ADDENDUM NO. 4

October 7, 2024

**South Westnedge School Remodel & Site Improvements
3333 South Westnedge Avenue
Kalamazoo, MI 49008**

This Addendum consists of Pages ADD 4-4 and attached TowerPinkster Addendum No. 4, dated October 4, 2024, consisting of 43 pages.

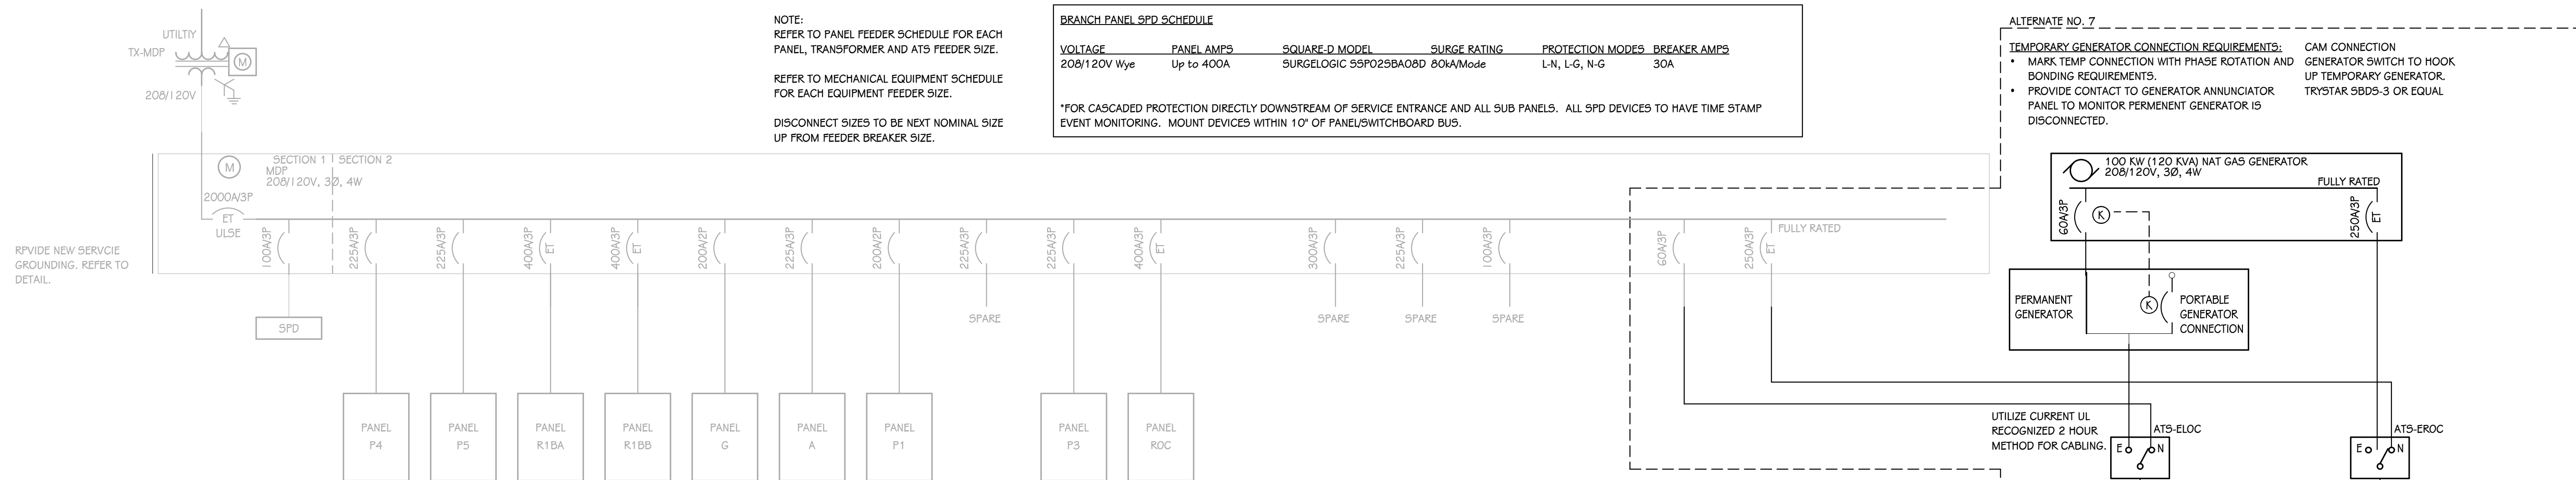
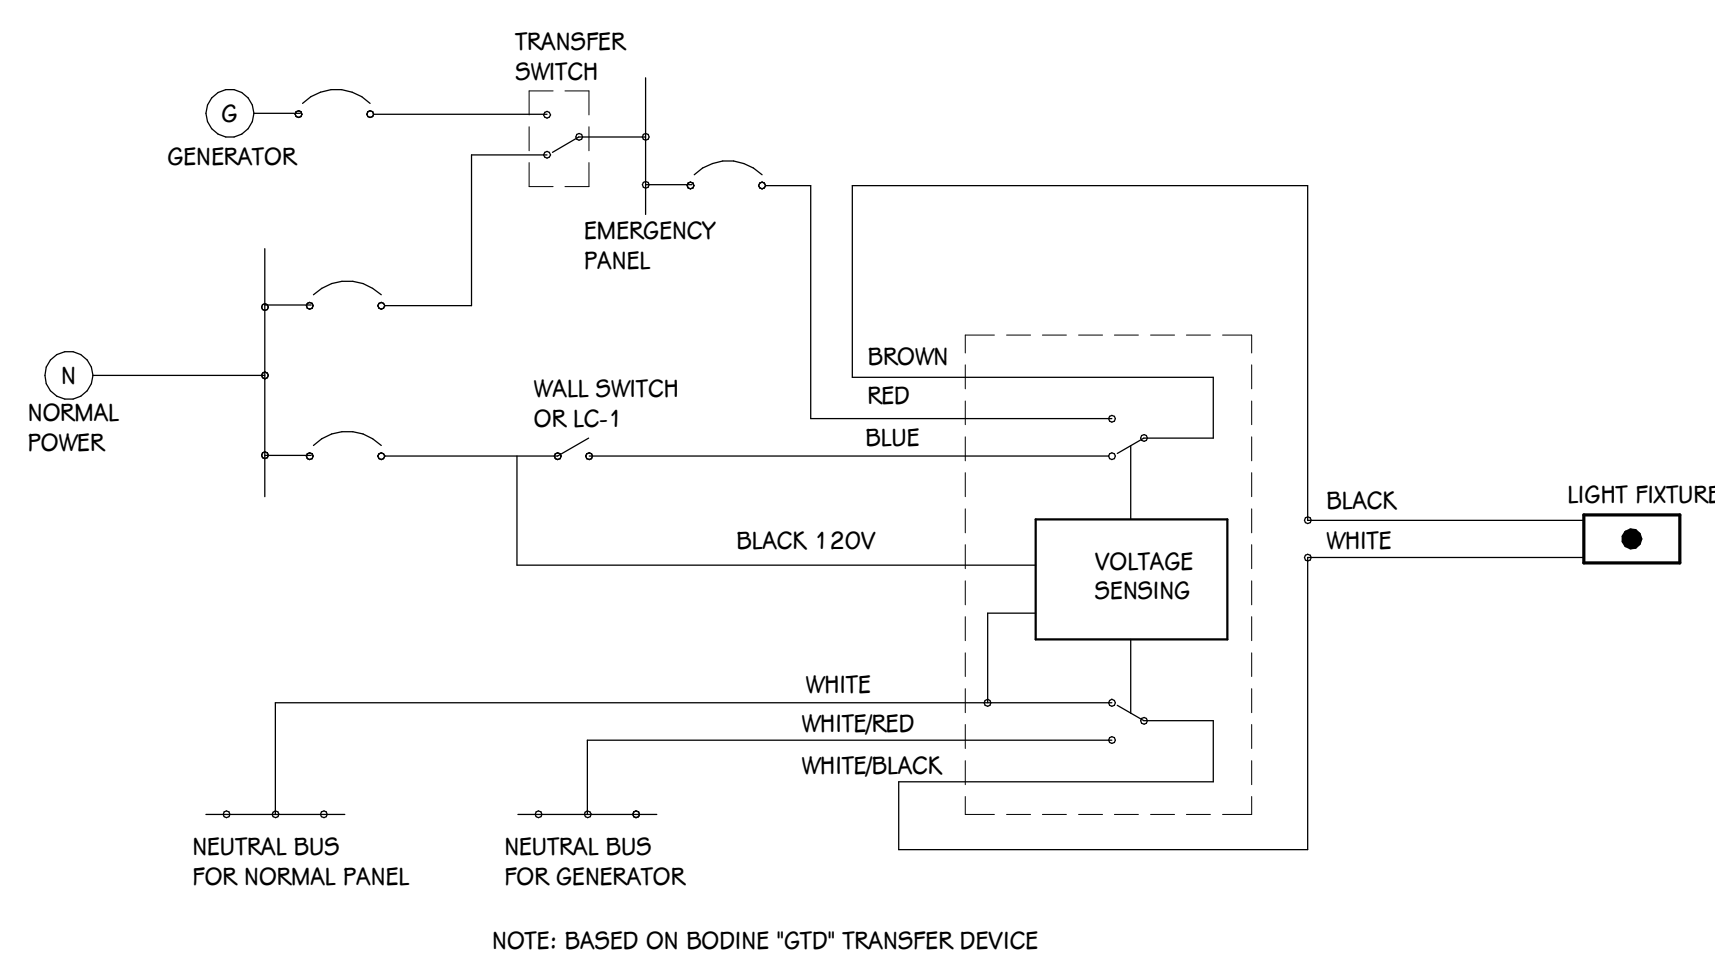
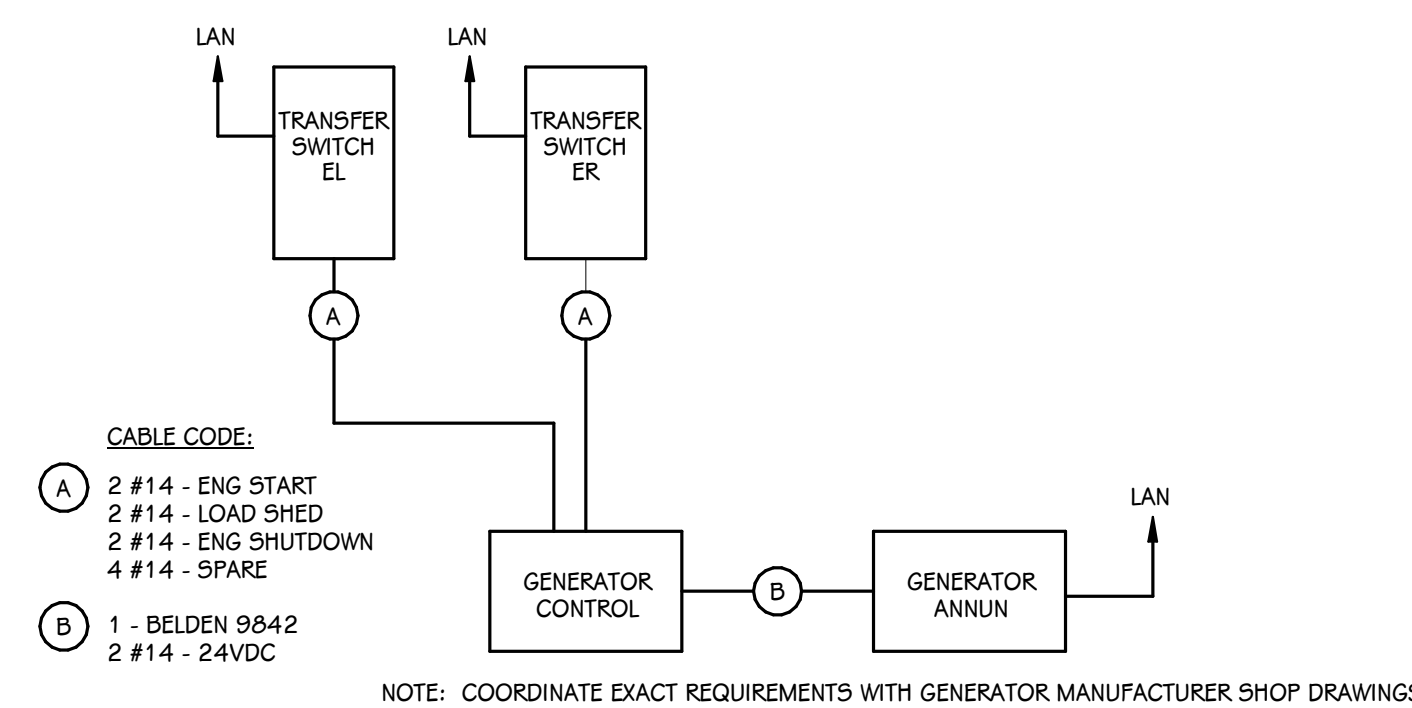
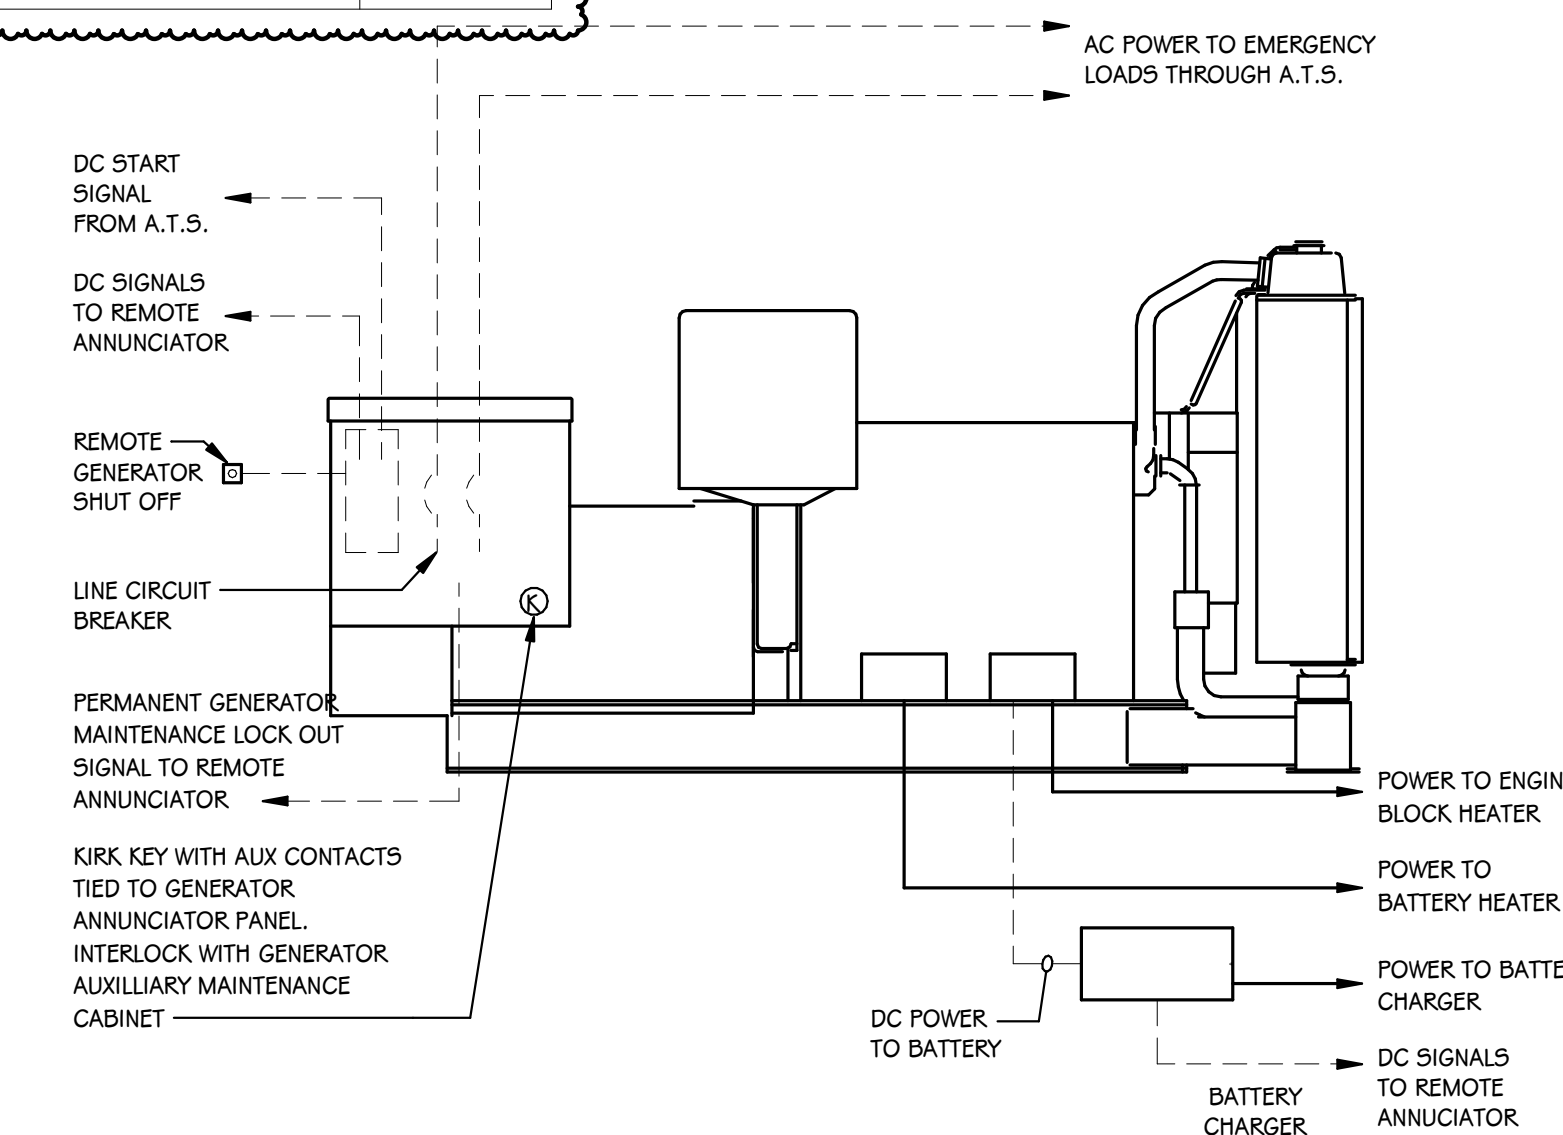
Refer to Sheet(s): E404 and E803

Added light fixture equals to base bid and alternate light fixtures.

Added alternate light fixture schedule to sheet E803.

Added equal manufacturers for lighting control.
